80960CA/CF SPECIFICATION UPDATE

Release Date: July, 1996

Order Number: 272875-001

Figure 1: Timings for Correct Operation

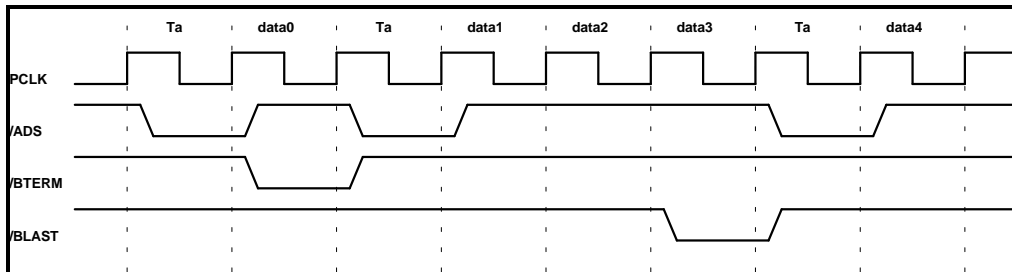
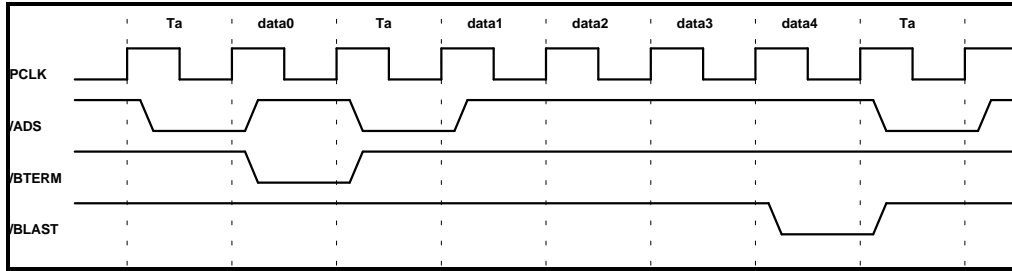
If BTERM# is asserted during data(0), ADS# will be asserted again for data(1) and the access will end by asserting BLAST# while reading data(3).

The access spans over data3. For example, BLAST# is asserted while data4 is read.

IMPLICATION: Memory and I/O systems must accept these forms of access when using BTERM.

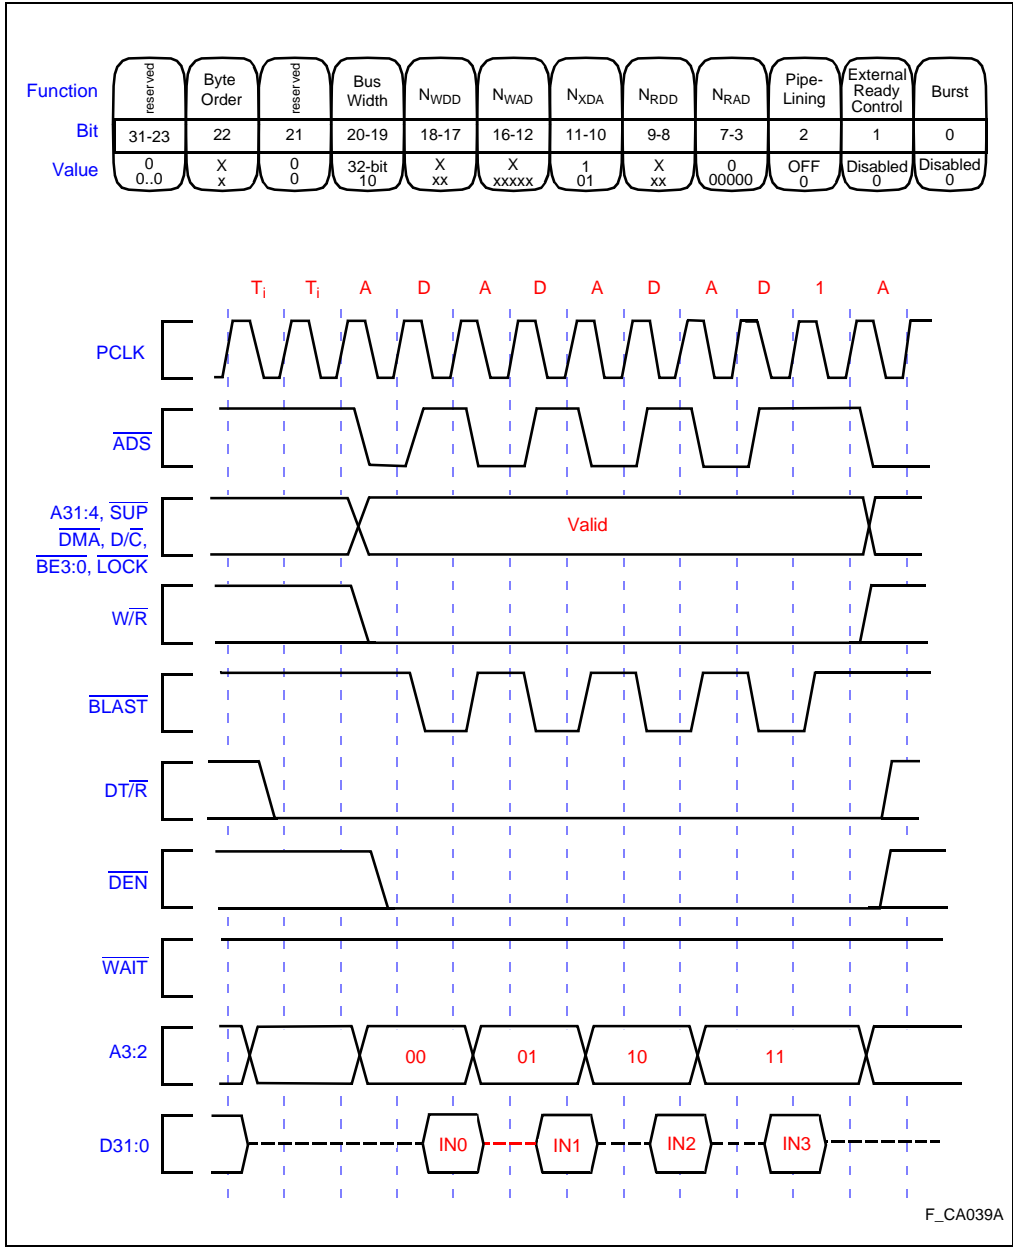
"When executing a sysctl instruction to load and lock either half or all of the cache, it is necessary to provide a cache load address. The last two bits of the cache load address must be 10base2 for the cache locking mechanism to work properly."

Modes 100₂ and 110₂ select cache load-and-lock options:

- On the CA: mode 100₂ loads and locks the full 1 Kbyte cache, 110₂ loads and locks half the cache.
- On the CF: either mode (100₂ and 110₂) loads and locks half the cache.

The **sysctl** instruction’s field 3 must contain an address; this address points to a quad-word aligned block of memory in the external address space. Instructions starting at this address are loaded into the cache. These instructions can only be accessed by selected interrupts which vector to these instructions’ addresses. The load-and-lock mechanism selectively optimizes latency and throughput for interrupts.

Figure 12-6. Interrupt Control (ICON) Register

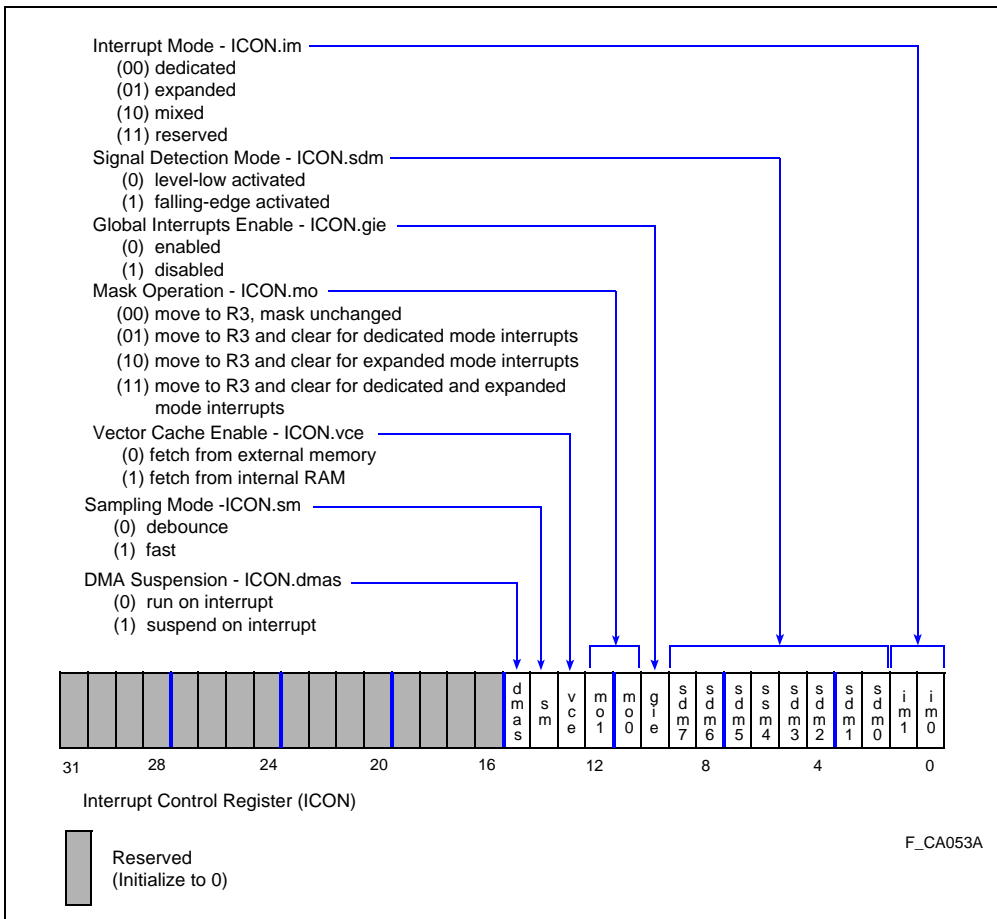
ITEM: Page 12-11 Figure 12-6. Vector Cache Enable bits (ICON.vce) are incorrectly defined.

Errata (12-06-94 SRB)
 Vector Cache Enable bits (ICON.vce) incorrectly defined.
 Bit 0 was "debounce"; it now is correctly defined as "Fetch From External Memory".
 Bit 1 was "Fast"; is now correctly defined as "Fetch From Internal RAM".

Figure B-2 shows a Non-Pipelined SRAM Read Waveform; Figure B-3 shows a Non-Pipelined SRAM Write Waveform.

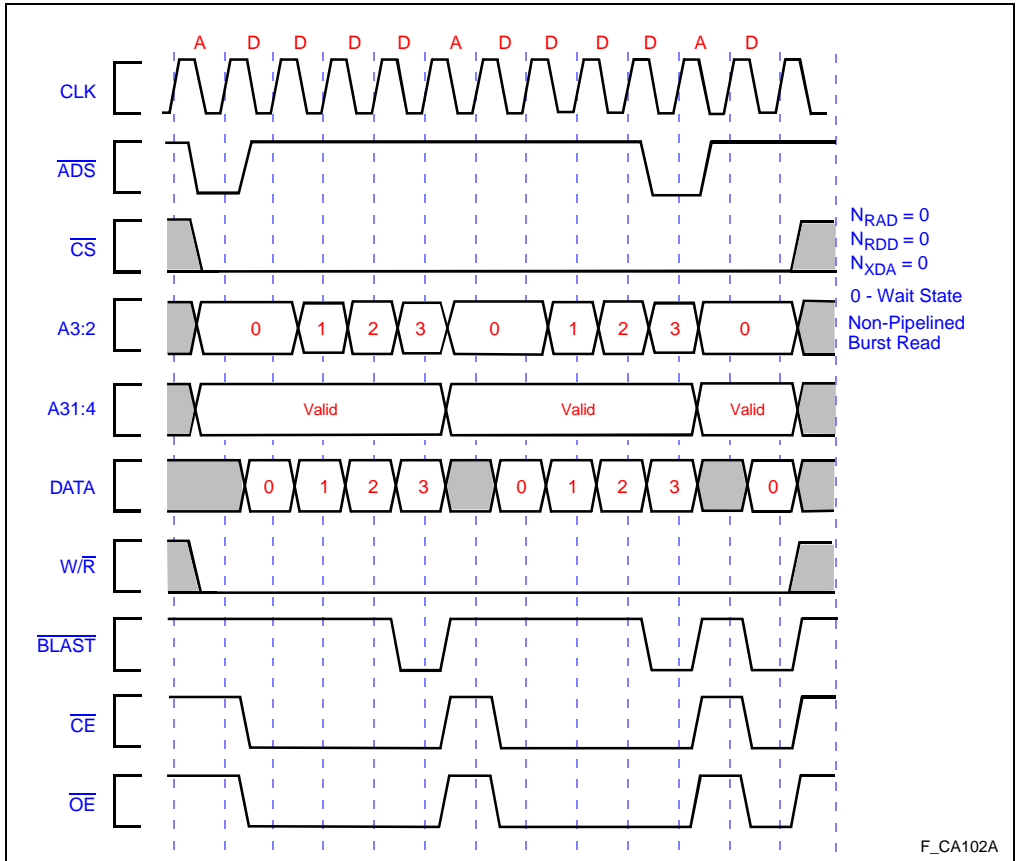
ERRATA (10-31-94) SRB
 On pg B-5, Fig B-3, the ADS# signal incorrectly showed a deassertion in the 6th cycle and the 3rd deassertion in the 11th cycle.
 It now correctly shows NO deassertion in the 6th cycle and the last deassertion in the 10th cycle. (2nd deassertion removed; 3rd deassertion shifted left 1 cycle).

Figure F-16. Interrupt Control (ICON) Register

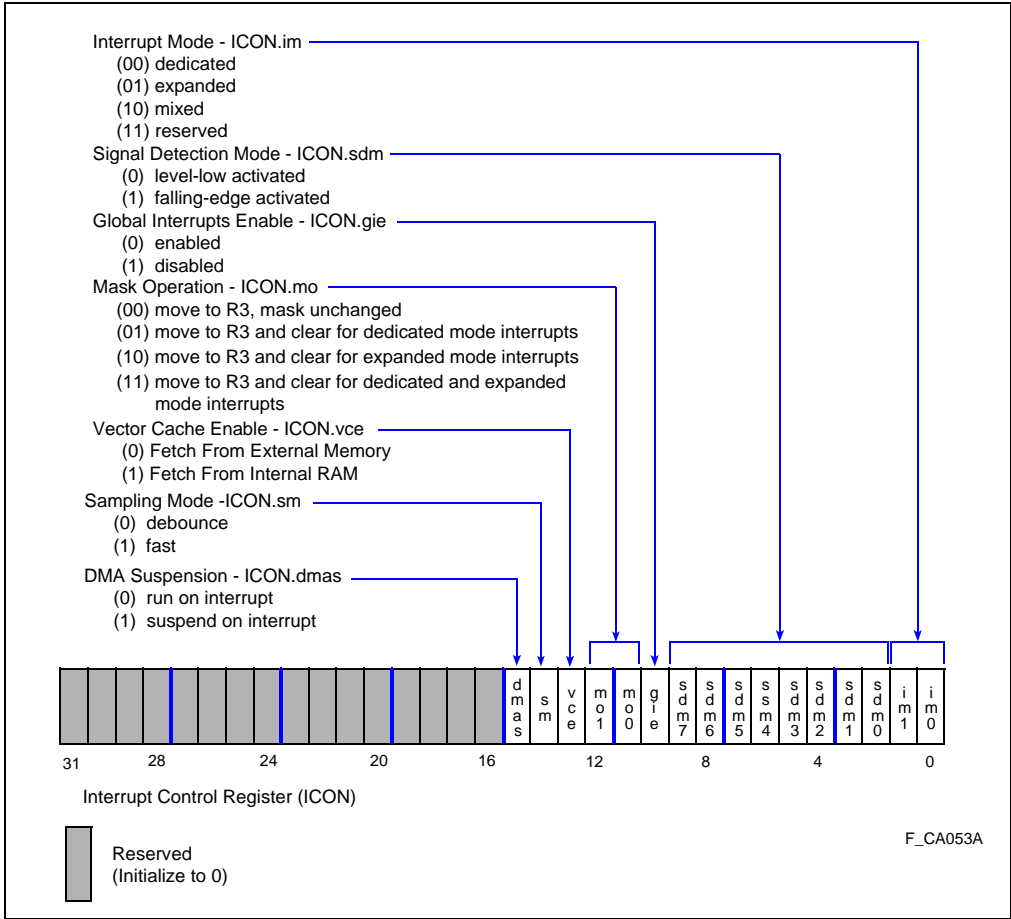
ITEM: Appendix F is a compilation of all registers and data structures; therefore, this appendix has the same errata indicated in Figure 13-9 and Figure 12-6.

Errata (12-06-94 SRB)
 Vector Cache Enable bits (ICON.vce) incorrectly defined.
 Bit 0 was "debounce"; it now is correctly defined as "Fetch From External Memory".
 Bit 1 was "Fast"; is now correctly defined as "Fetch From Internal RAM".
